New door lock

Fitted appliances (new design)

From November 1998 onwards (serial number 848 ...), a new door lock is being installed gradually in the dishwashers listed below. This door lock reduces the door closing forces and also ensures tightness despite the lower closing forces.

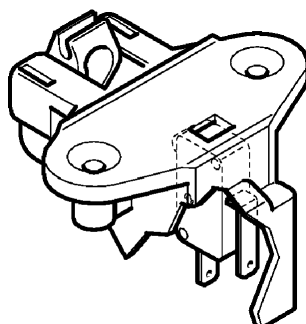
This new door lock must be installed together with the new handle.

- The new components (items 344 and 7) cannot be replaced individually. This means you cannot replace one old part with a single new part.
- This new door lock must be installed together with the new handle (items 344 and 530).
- The new door handle (item 530) can replace the previous handle but not vice versa (i.e. the new handle can be used with the previous lock).

If a new door lock is installed instead of the old one, an insulation sleeve (A) must be used for the AMP plug. This applies to the connecting lug which has the shortest distance to the inner door (See Fig.).
